PD Modification Application: PRS 22-1494
Zoning Hearing Master Date: N/A
BOCC Land Use Meeting Date: December 13, 2022

APPLICATION NUMBER: PRS 22-1494

AGENCY REVIEW COMMENT SHEET

8.1 Approved Site Plan (Full)

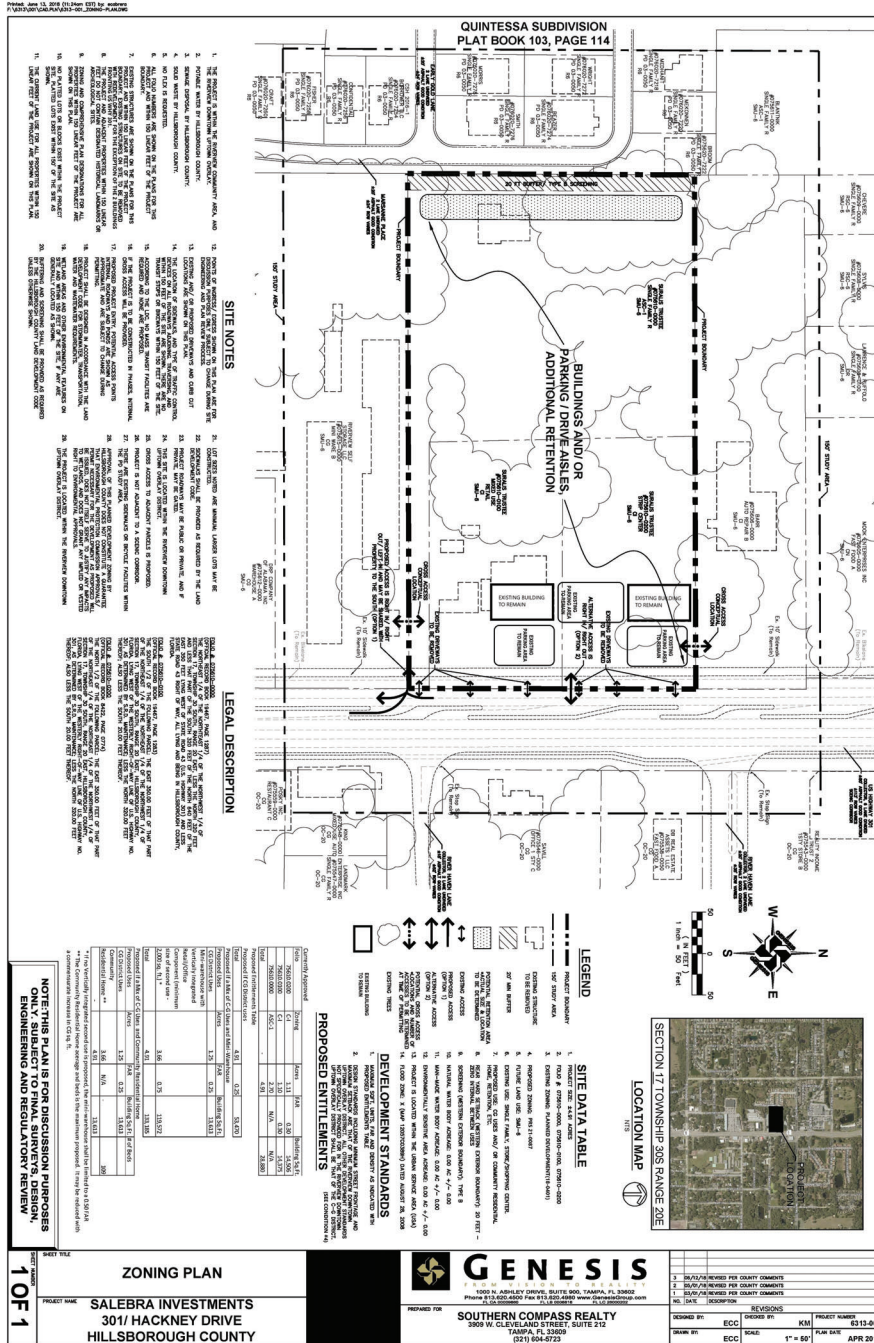
- 1. Enhanced screening details described in the Legend to match Condition #5 or refer to Condition #5.
